PR-2024-009995

VA-2024-00036 – WAIVER TO IDO
IDO - 2022

REQUEST: WAIVER TO UNDERGROUND REQUIREMENT OF NEW ELECTRIC DISTRIBUTION FEEDERS

Project Name: South University ROW between Clark Carr Rd SE and city boundary (just north of Los Picaros Road SE)

Snake Sculpture leading to Mesa del Sol

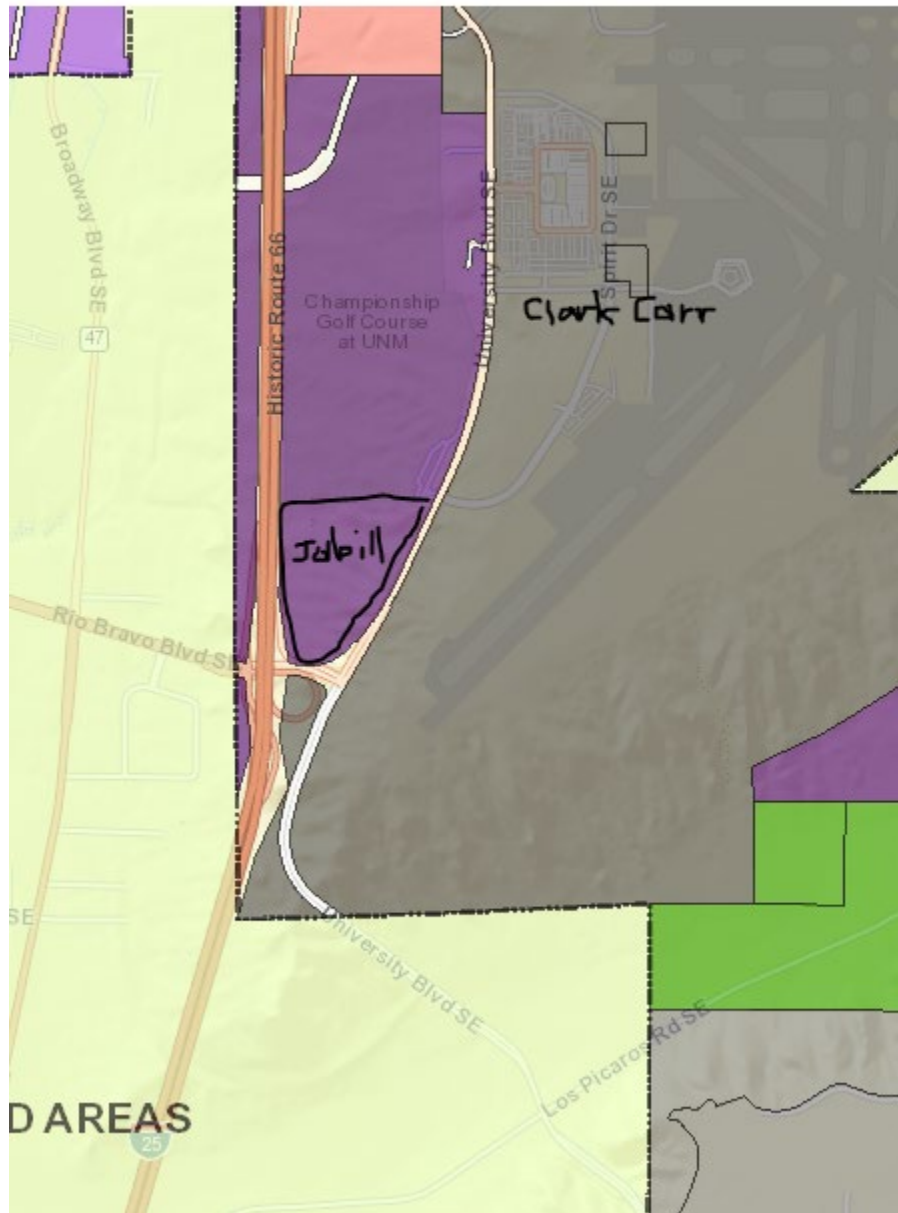
1. There is a public purpose to not having overhead lines in this area. There is high potential for growth along this section of University Avenue with the growing market for the Sunport, UNM, and the entrance to Mesa del Sol. The road section currently has a sense of intrigue as it traverses a unique landscape and interesting ‘snake sculptures’ in the median. In general, overhead utility lines would detract from the economic development potential of this corridor. It is important to note that the IDO criterion requiring undergrounding of distribution lines does not give nonresidential land a lesser priority for the undergrounding of distribution lines. This significant stretch of University does not currently have overhead electric lines. Therefore, there is a significant public purpose achieved by the undergrounding of the electric lines.

University leads through unique topography in Albuquerque with a sense of going to an intriguing place.
